**PROPOSED HOUSING DEVELOPMENT  
AT WOODTOWN, BALLYCULLEN,  
DUBLIN 16**

**Stage 1 Quality Audit**

**(Incorporating a DMURS Street Design Audit, and Audits  
of Accessibility, Cycling, Walking and Road Safety)**

**WATERMAN MOYLAN**

**Figure 7 – Horizontal alignment issues of kerb lines**

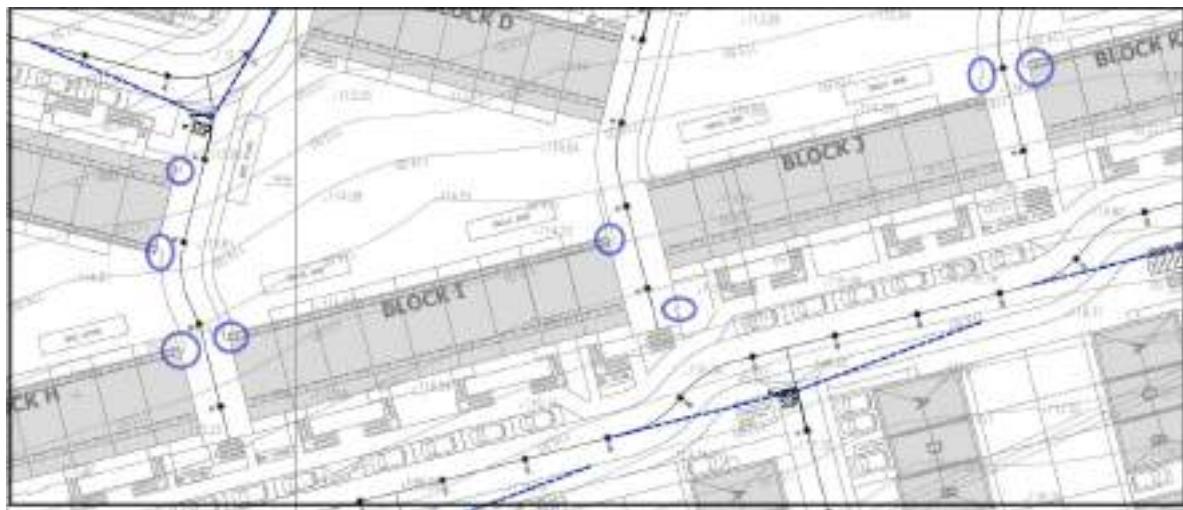
The width of the roadway changes abruptly at a number of locations on the shared space streets. See Figure 7 below for examples of these locations. Drivers, taking guidance from the kerb lines, may collide with the kerb line or oncoming vehicles due to the abrupt changes in direction of the kerb lines.

Remove abrupt changes in the carriageway width along the proposed shared space streets.

**Figure 8 – Discontinuity in footpath near Abbots Grove entrance**

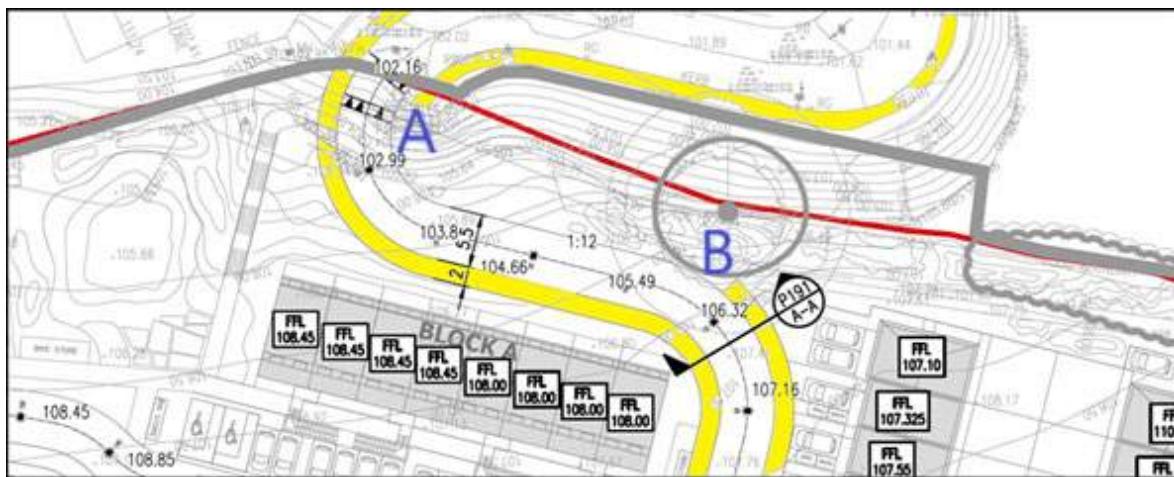
There is a discontinuity in the footpath at the entrance to the site from the Abbots Grove direction. The footpath on the right-hand side on the drawing (from A to B) finishes some distance before the entrance to the development. The footpaths at the entrance are highlighted in yellow on Figure 8.

The natural route for at least half of the pedestrians using this exit would be on the side of the road where the footpath has been terminated.

Additionally, there is no pedestrian crossing shown on the drawings to possibly aid people to cross the road at this point. This could lead to vulnerable road users taking risks at this location, leading to collisions and injuries.

Consideration should be given to reviewing the footpath layout at this entrance to provide a continuous footpath for vulnerable road users along here.

**Figure 9 – Footpath with steps through open area**

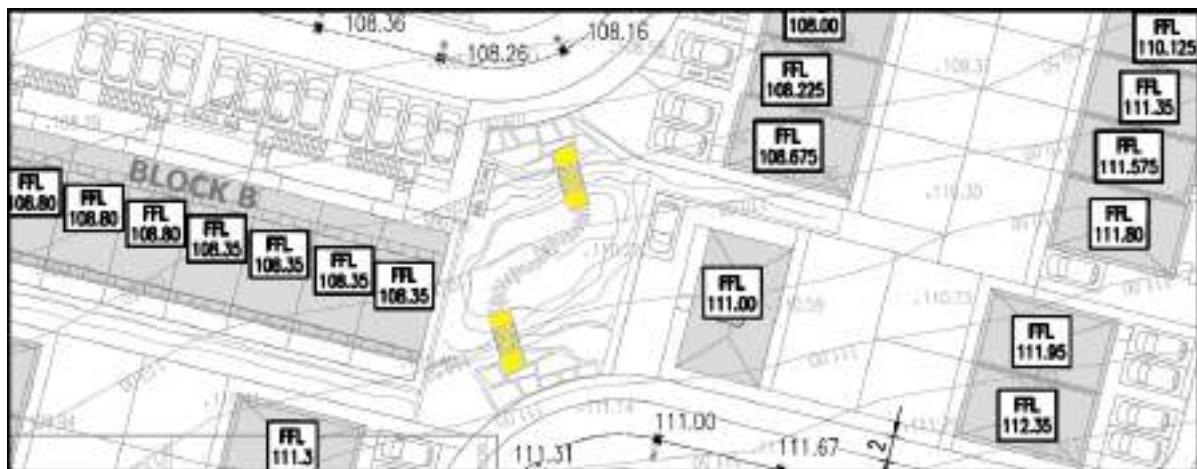
A pathway is indicated through the open area near block B, and due to the difference in levels between the two roadways, there are quite a number of steps on this pathway. The crossfall in the open areas usually ranges from two to three meters due to the topography. See Figure 9 highlighted in yellow.

However, vulnerable road users, including wheelchair users, cyclists and parents with children and prams, will not be able to avail themselves of this pathway. No facility appears to have been made available for them, and they will have to travel for quite a distance to get to the other side of this pathway.

**Figure 11 – Footpath travels under stairways**

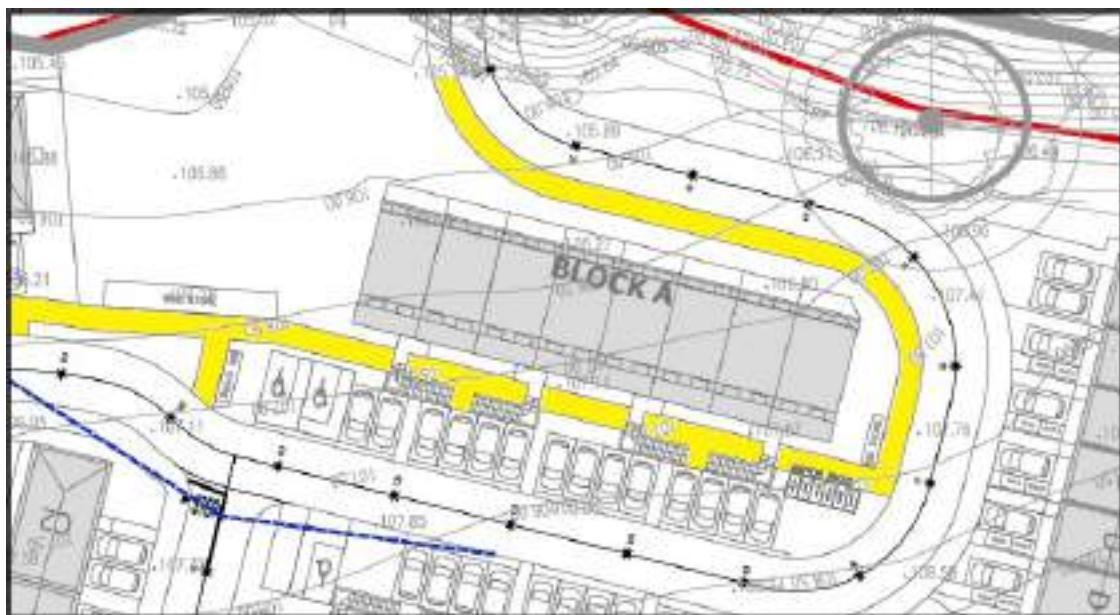
Figure 11 shows the footpath at the entrance from Abbots Grove to the development. The footpath appears to travel underneath the steps of apartment block A. It is unclear of the clearance height beneath the steps and as such might be a concern for a number of pedestrians. This situation also pertains in a number of other apartment blocks in the development.

**Figure 12 – Pedestrian access to the Creche**

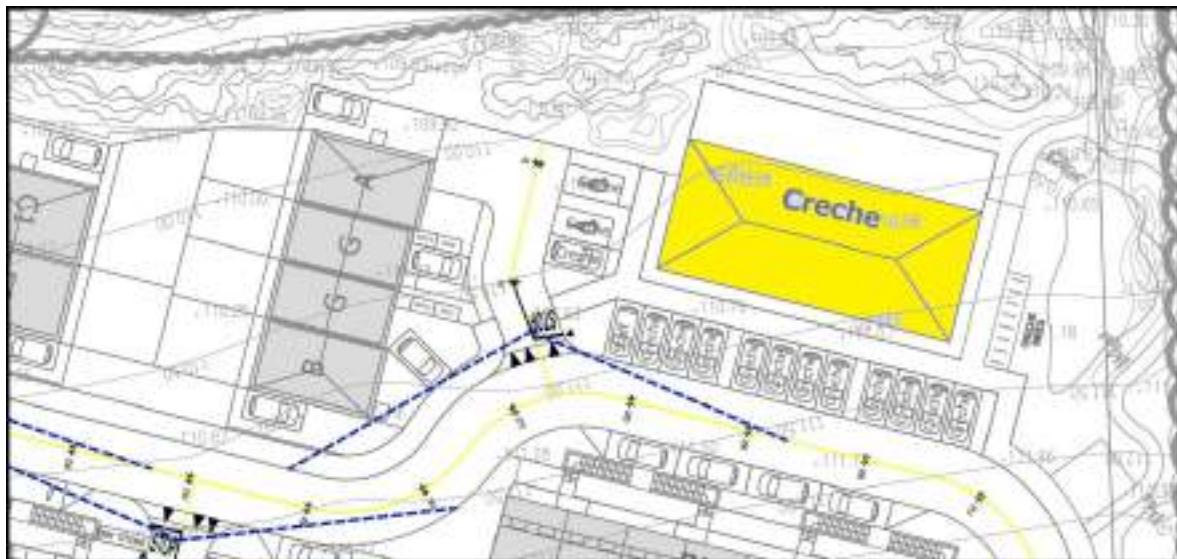
Figure 12 shows the location of the Creche, on the northern boundary of the site. The cul-de-sac road to the left of the Creche building has a table at the junction, so pedestrians on the northern side of the road can access the Creche without any difficulty.

However, there are no pedestrian crossings or tables shown on the drawings from the southern side of this site, which will make it difficult for vulnerable road users to cross the road and access the Creche. Additionally, the parked cars will make it difficult for pedestrians and people with prams and buggies to access the Creche.

6.7	Yes	Yes	Please refer to the updated road drawings which now include all the proposed crossings.	-----
6.8	Yes	Yes	Please refer to the Landscape architect drawing which indicates all of the proposed pedestrian/cyclist facilities throughout the site.	-----

**Figure 13 – Footpath discontinuity**

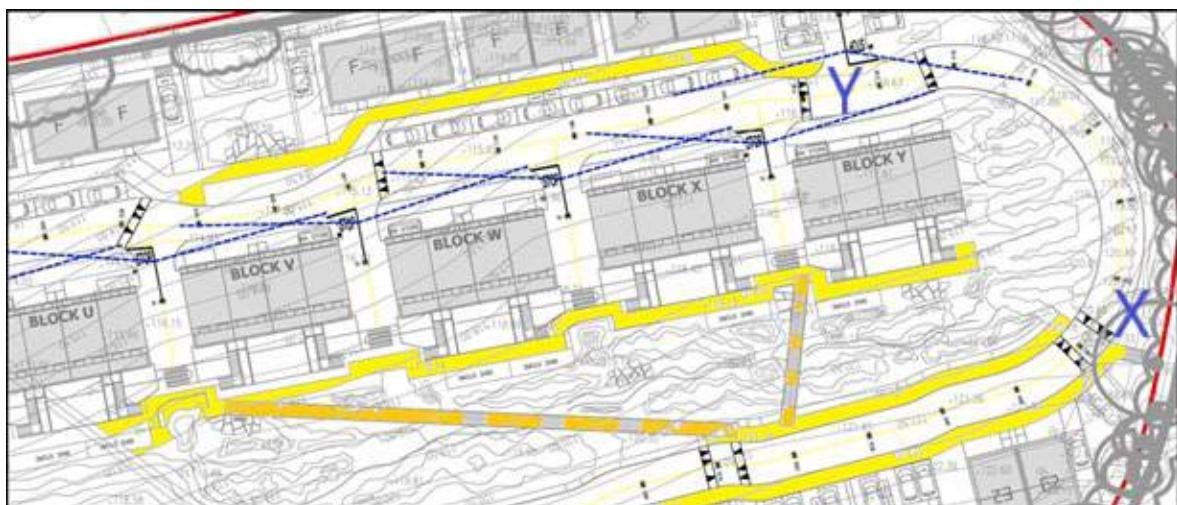
There appears to be discontinuity in the footpath on the eastern boundary of the site (from point X to point Y) - see footpaths highlighted in yellow on Figure 13 below. Although there are tables to allow vulnerable road users to cross the road, the footpath does not extend along the eastern boundary of the site. There are two paths with what appears to be steps (highlighted in orange) linking up to the back of the apartment blocks, but for vulnerable road users, disabled persons and cyclists these are not fit for purpose.

**Figure 14 – Footpath discontinuity**

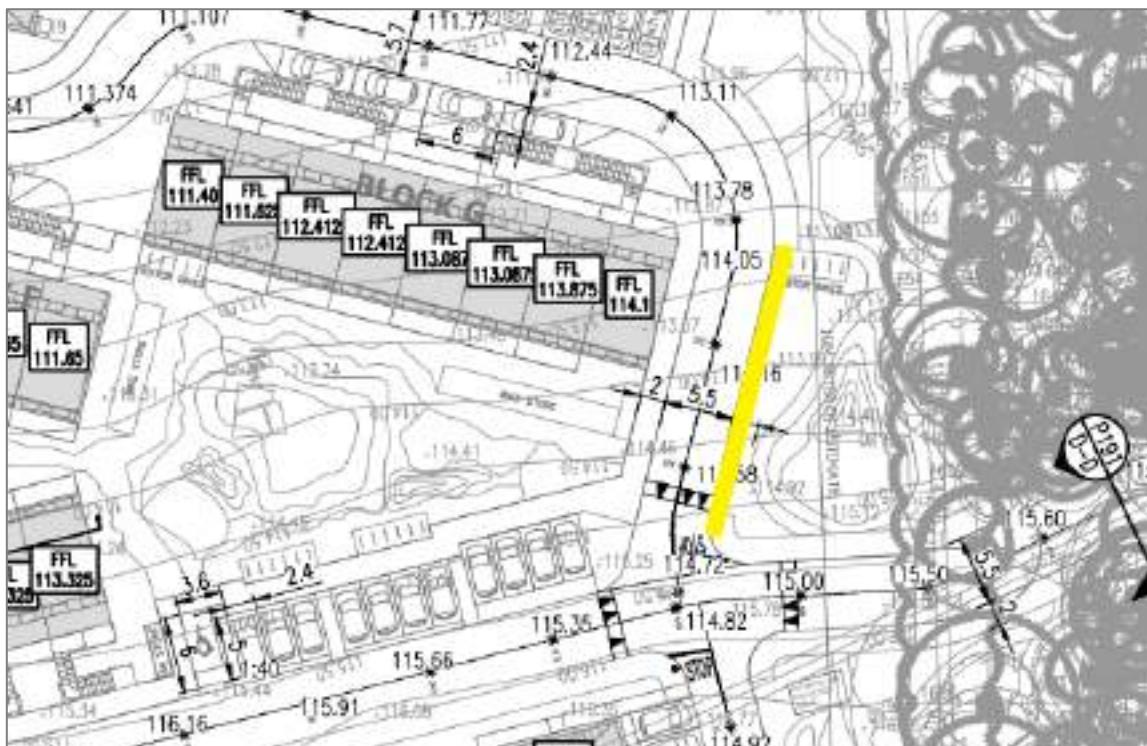
There appears to be discontinuity in the footpath on the eastern side of the access road at Block G. (from point X to point Y) - see footpaths highlighted in yellow on Figure 13 below. Although there is a table to allow vulnerable road users cross the road at the southern termination point, the footpath does not extend along the eastern side of the access road.

Consideration should be given to reviewing the footpath layout at this location to provide a continuous footpath for vulnerable road users along here.

6.9	Yes	Yes	Please refer to the Landscape architect drawing which indicates all of the proposed pedestrian/cyclist facilities throughout the site.	-----

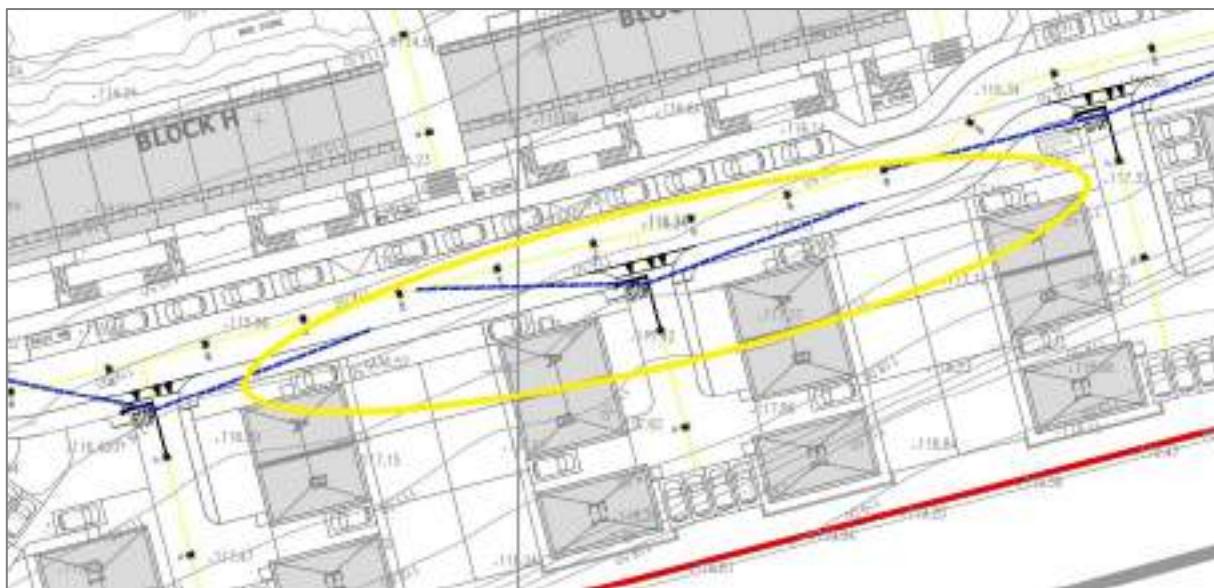
There are a number of locations where parallel parking spaces are proposed to the rear of footpaths in close proximity to the adjacent building. It is unclear if such parallel parking spaces are readily accessible at such an offset from the adjacent carriageway.
